APPLICATION FOR  
URBAN DESIGN COMMISSION  
REVIEW AND APPROVAL

AGENDA ITEM # \_\_\_\_\_  
Project # 8-101-13  
Legistar # 31340

**Subject:** 1220 - 1236 Mound Street

Re: Letter of Intent  
PD-GDP-SIP Submittal  
St. James Cottage Homes  
1220, 1226, 1234, 1236 Mound Street  
Madison, WI

1 SITE PLAN  
C-1.1 SCALE: 1"=10'

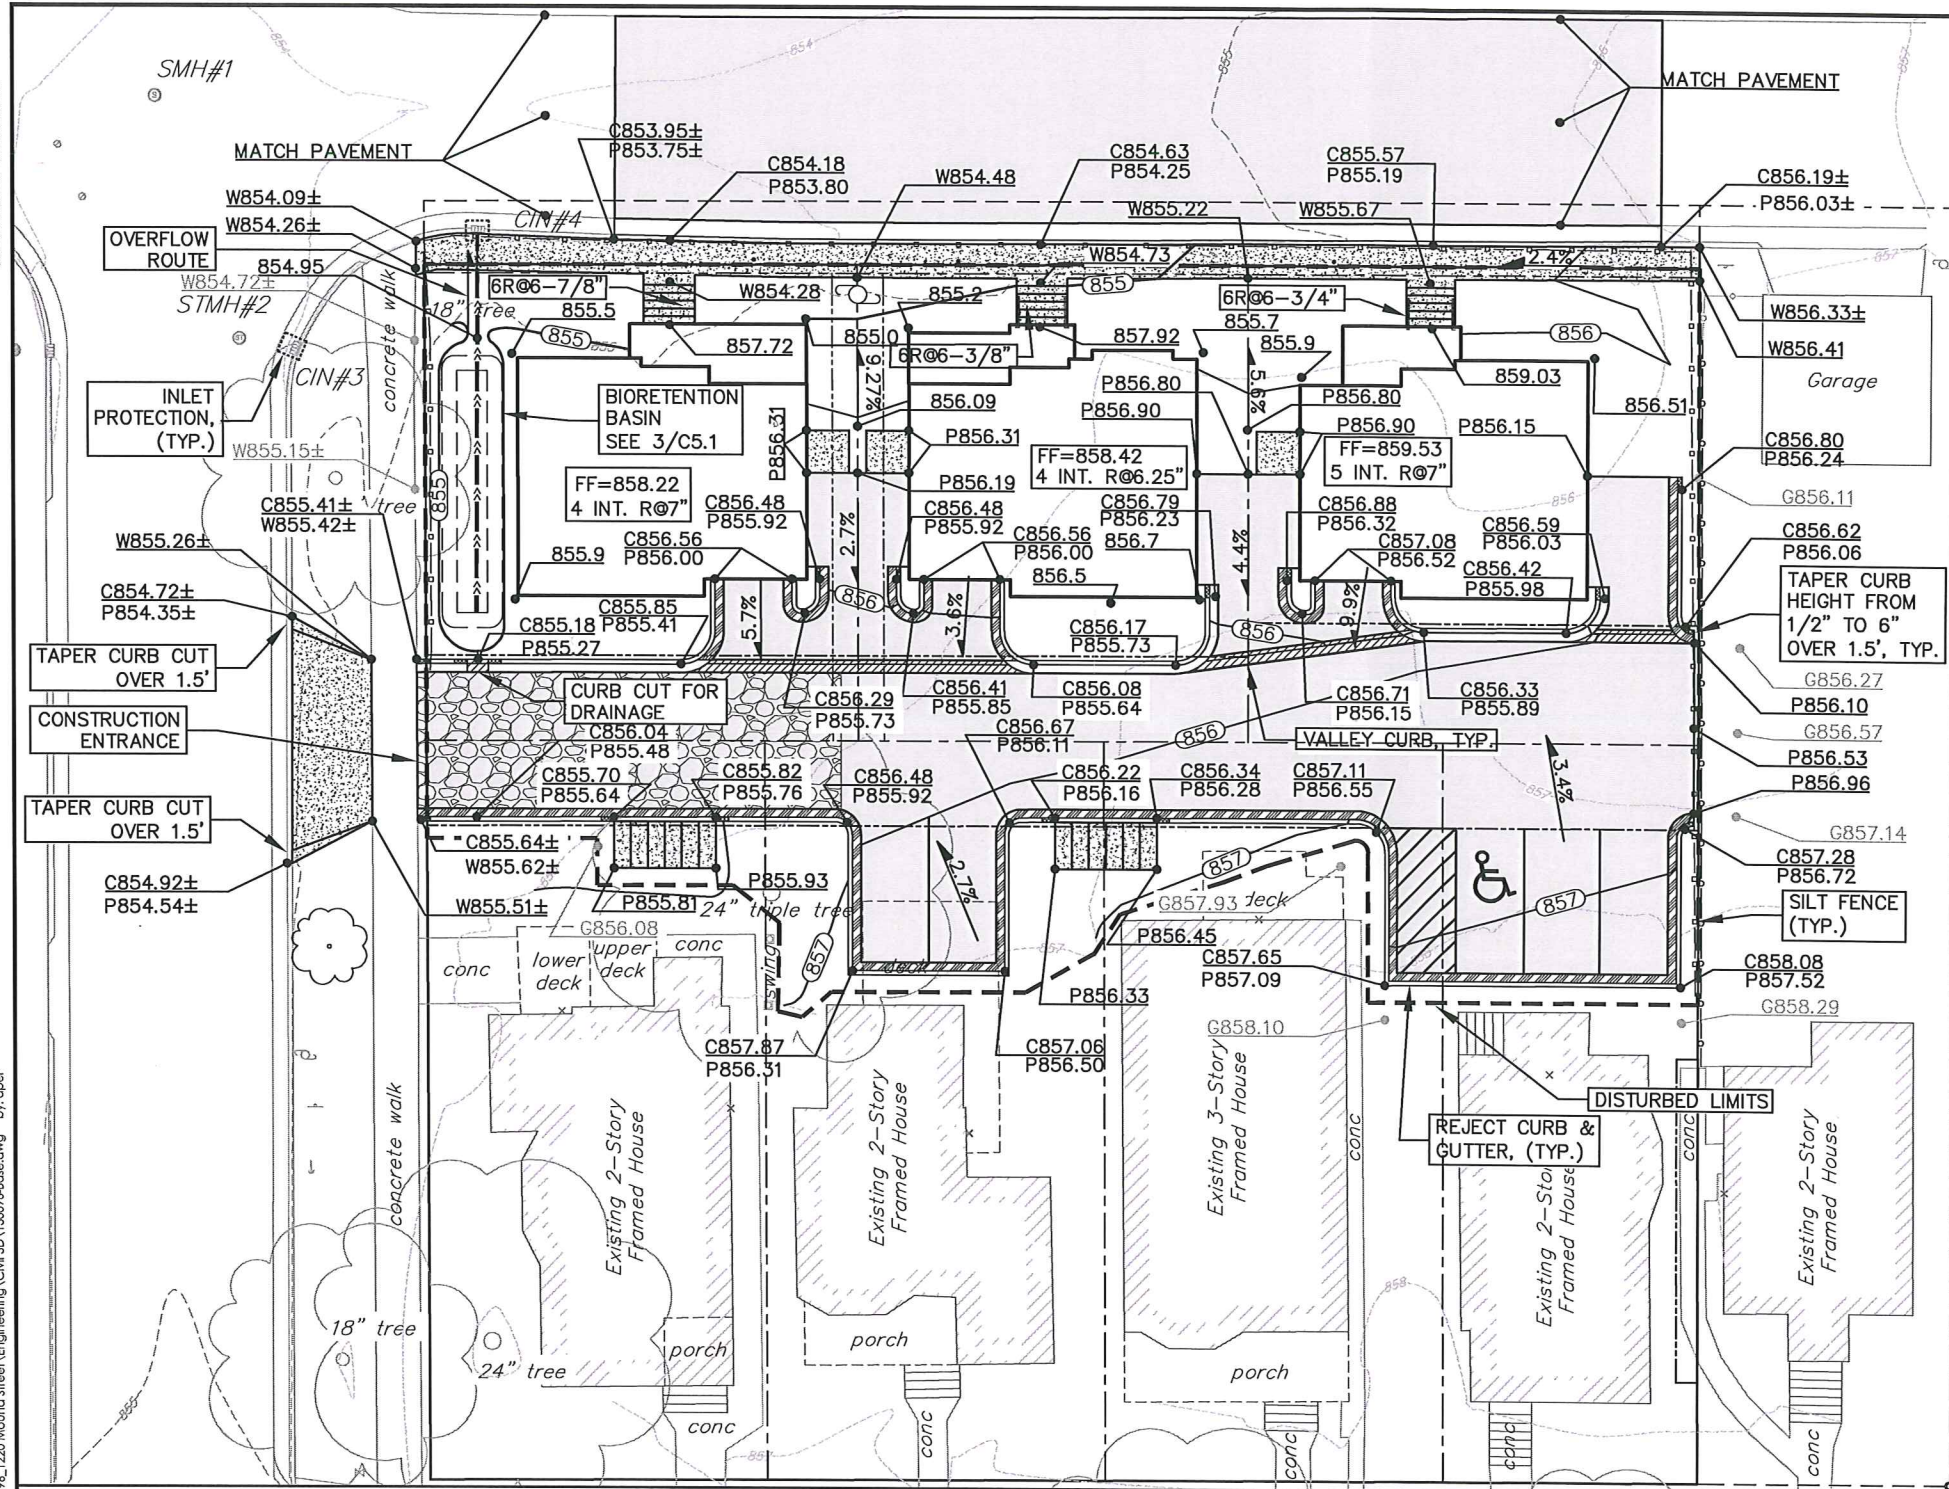
5. The front bay window on 1225 St. James Court was not previously depicted on the site plan and the resulting setback from the R.O.W. Has been reduced from 10 feet to 9.6 feet. All remaining setbacks are slightly larger than those previously approved.

6. The site plans have been adjusted to reflect coordination for the conditions of approval including adding 4 bike parking stalls and 2 car parking stalls. A concrete pad has been added at the new egress doors on the interior sides of the homes.

Elevations - Building A  
St. James Court

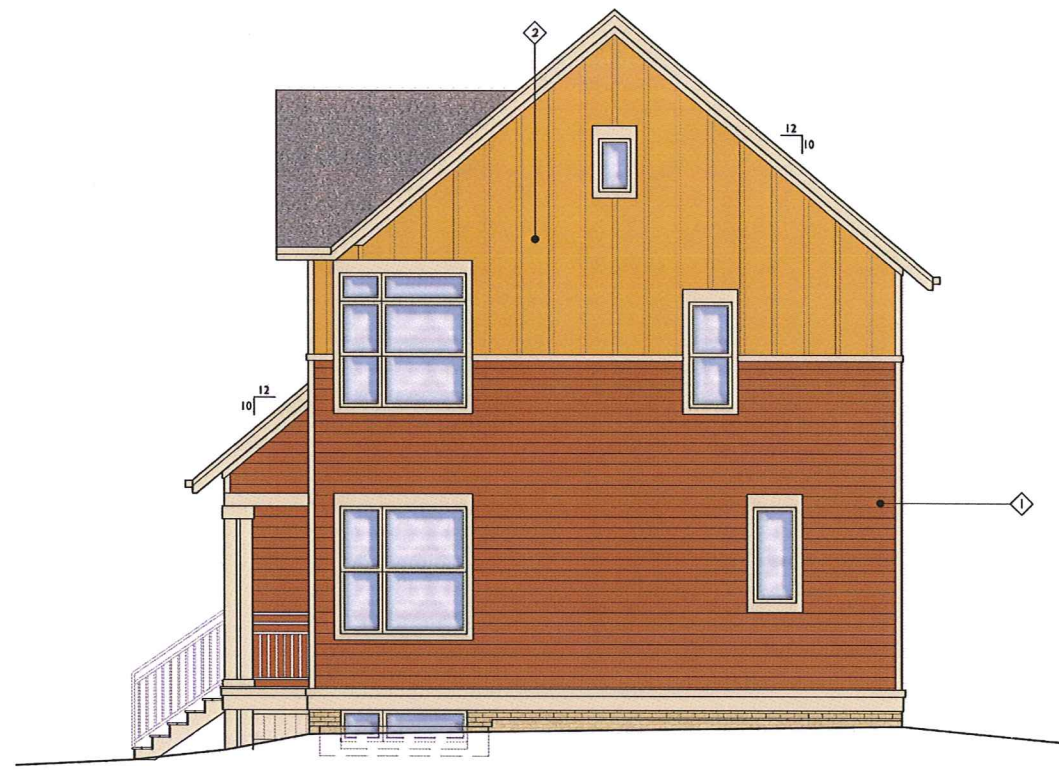
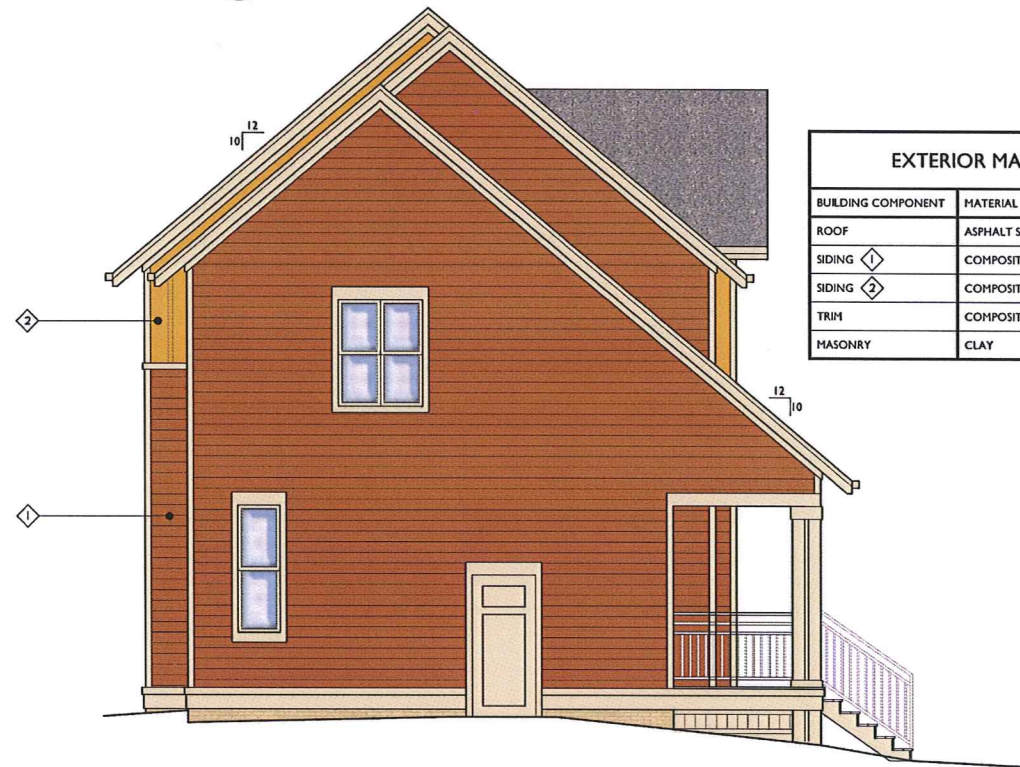
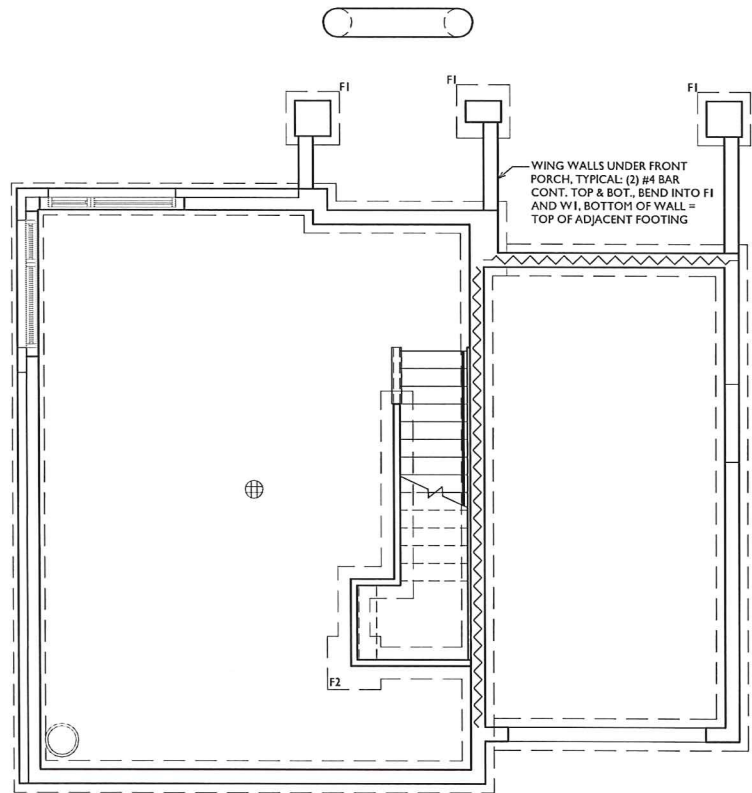
1. The base of the porches on Bldg. A – 1229 St. James Court (formerly Bldg. 1) and Bldg. C – 1221 St. James Court (formerly Bldg. 3) have been revised to a composite screen in place of masonry to better reflect the architectural character of those homes.

2. Grades have been adjusted around the the house perimeter to coincide with the latest grading plan. The building heights have adjusted by to reflect that. In two of the buildings the height is lower than previously shown (by 3-4 inches) but in for 1229 St. James Court the height is increased by 3-6 inches.

3. The lower sash height on many of the windows on all three houses was adjusted to meet the requirements for egress.
4. A required egress door from the garage was added to the side elevation of all three houses (these sides are inward facing, that is not exposed to the street or neighbor) . The first floor windows on 1225 St. James Court and 1229 St. James Court was adjusted to accommodate the added door and keep the exterior elevation balanced.
